Access Compliance Report Public Rights-of-Way (Curb Ramps)

Intersection ID: 51173 Main Street: OLD_PINEVILLE_RD Cross Street: KINGS_RIDGE_DR Location: SW

ADA ID: 703600205B09 Ramp Type: Directional1 Initial Pass/Fail: Fail Overall Compliance: No Severity Score: 1.25

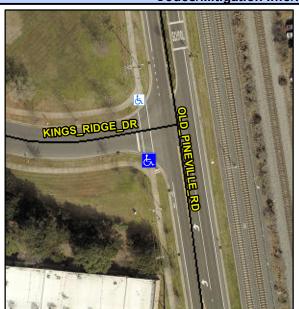
R304.5.3

Remove & Replace Entire Ramp.
